**TOWN OF BROOKLYN
PLANNING AND ZONING COMMISSION
Regular Meeting Agenda
Tuesday, February 21, 2023 6:30 p.m.**

- 2. **SP 22-007:** Special Permit for an Events Facility at 459 Wolf Den Road, Applicants: Nicole and Greg Fisher.
 - d. Other Unfinished Business:
 - 1. **SD 22-004:** One lot Resubdivision including 2 acres on Allen Hill Road/Wauregan Road (Map 31, Lot 97C), Applicant: Wayne Jolley/Lori Pike.

WILLOW HILL LLC

459 WOLF DEN ROAD

JOB NO: 22172 **DATE: NOVEMBER 30, 2022**
SCALE: 1" = 20' **SHEET: 6 OF 6**

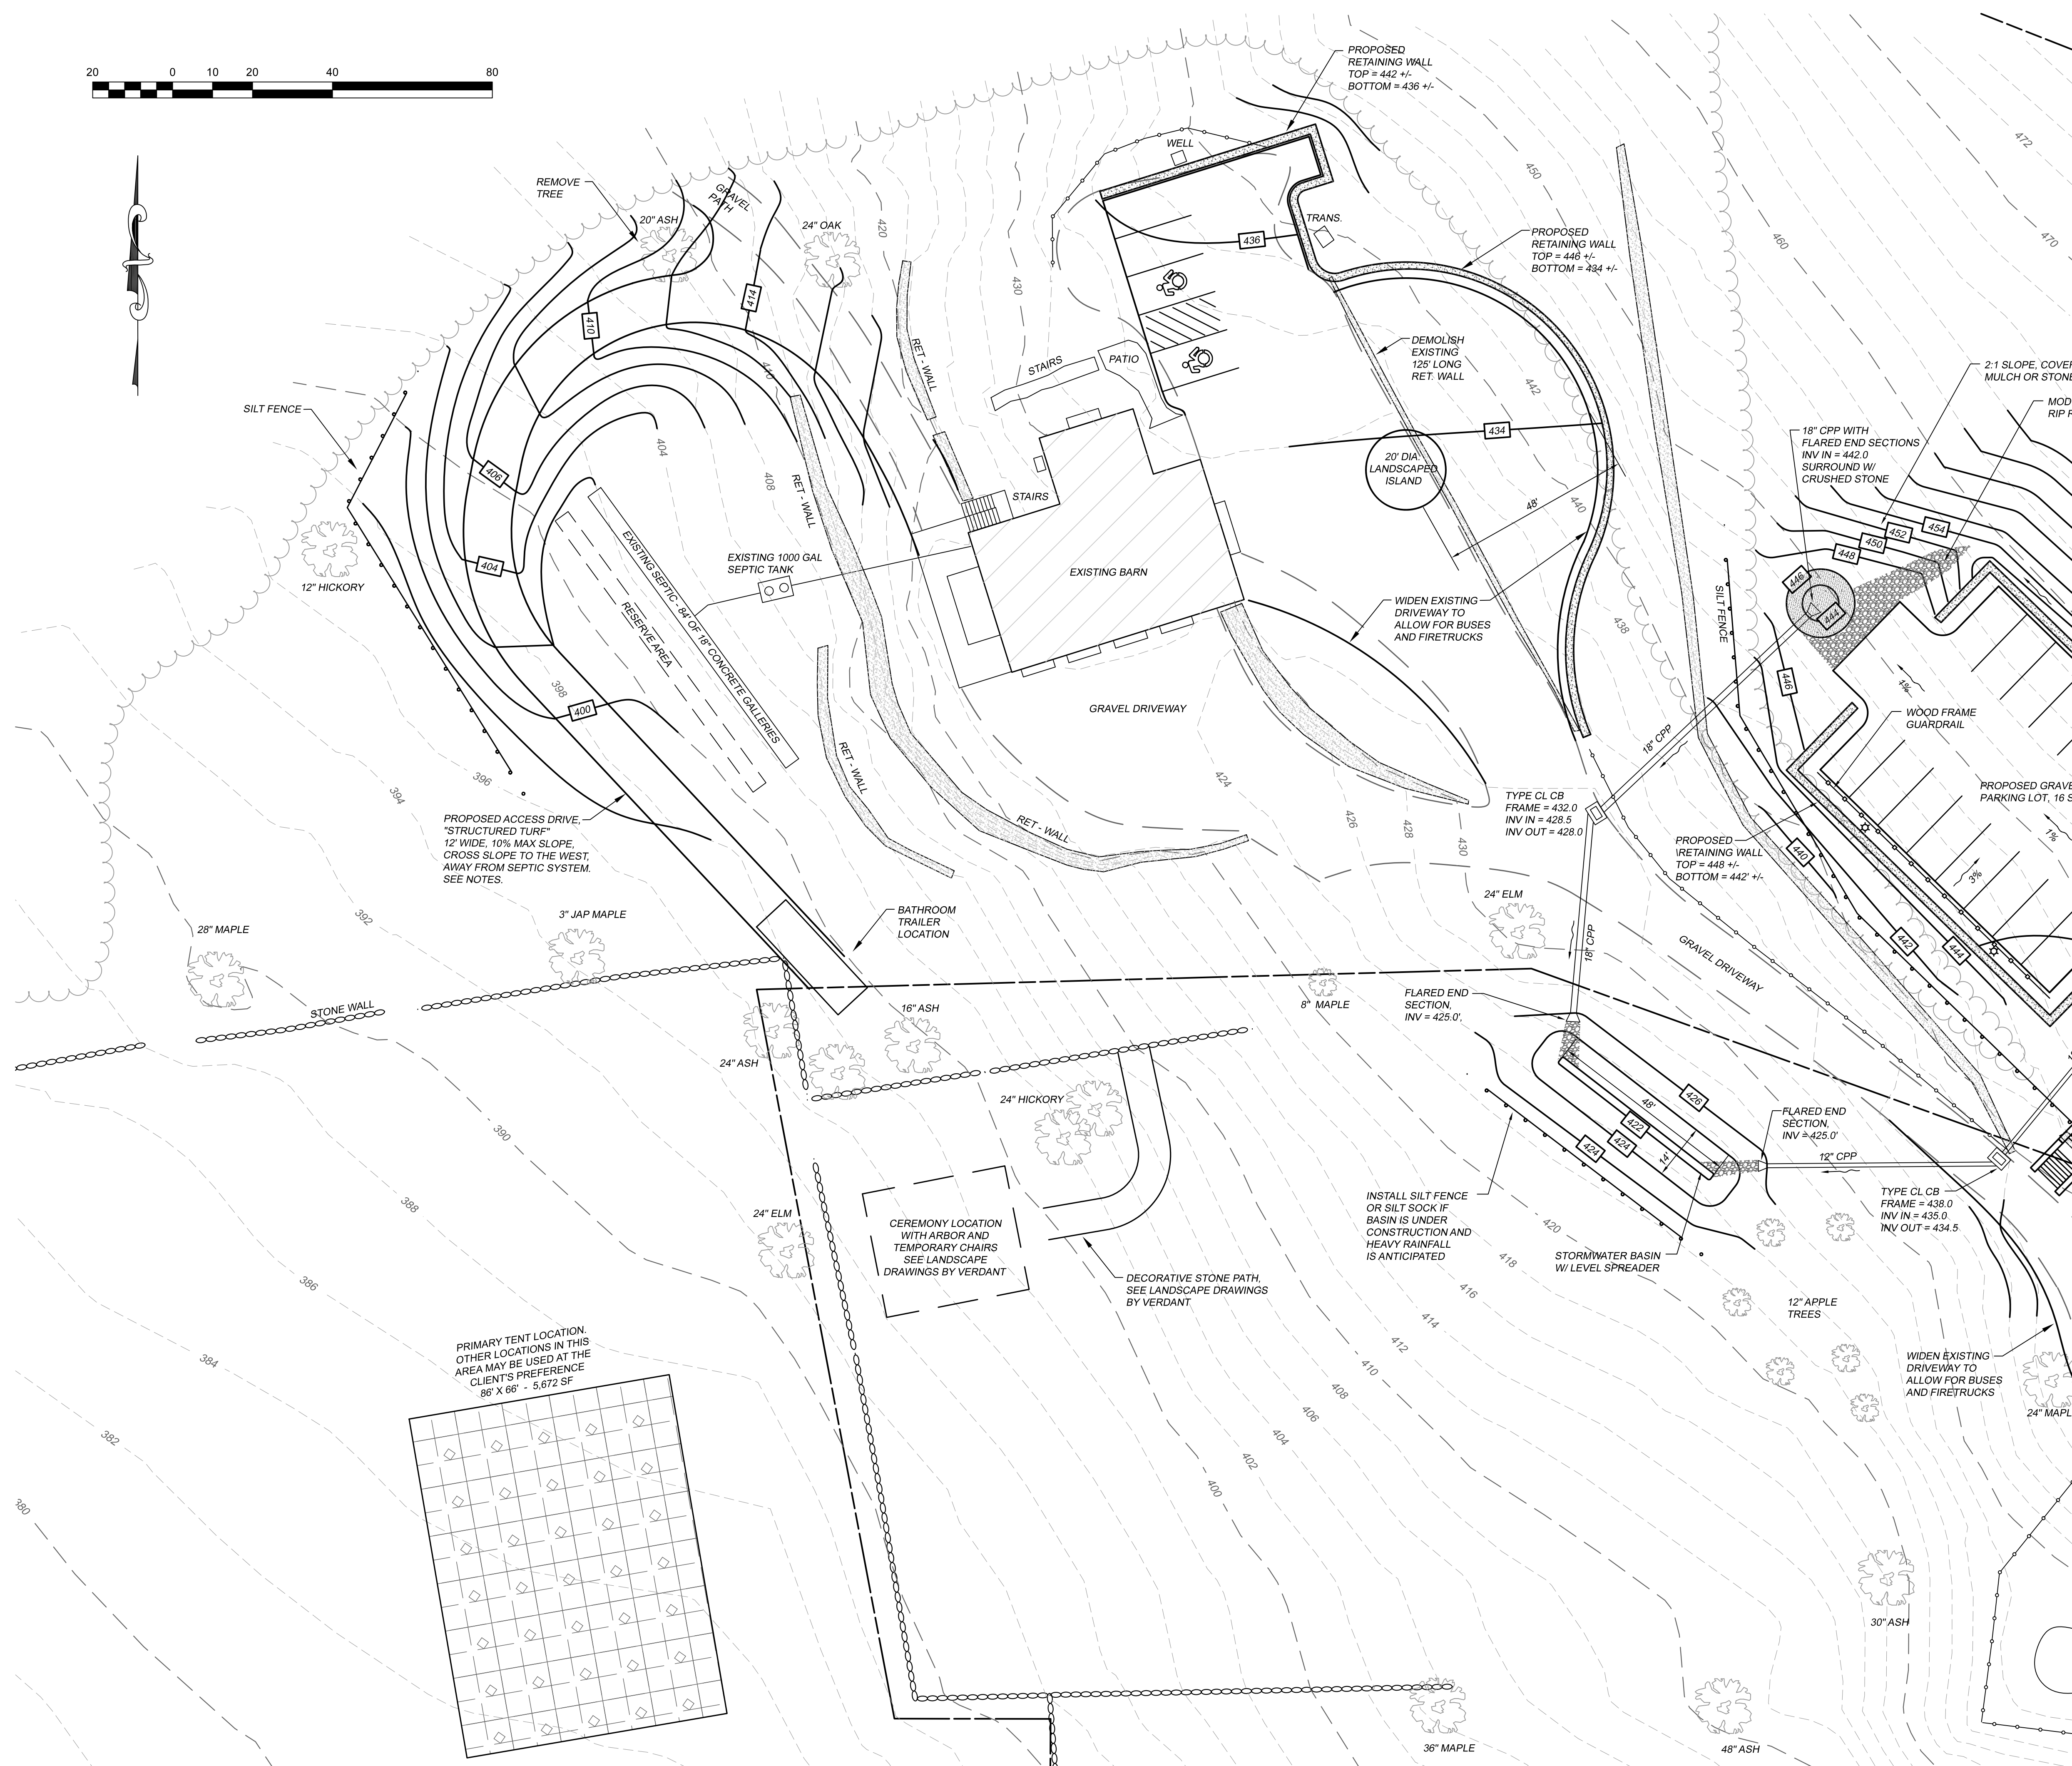
5. A “grass swale” detail needs to be included on this sheet.
6. This plan calls for a gravel surface parking lot but the Verdant Landscape Architecture plan (Drawing LP1) calls for crushed stone. Which is it? How will crushed stone perform under the stress of a snowplow if that is what will be installed?
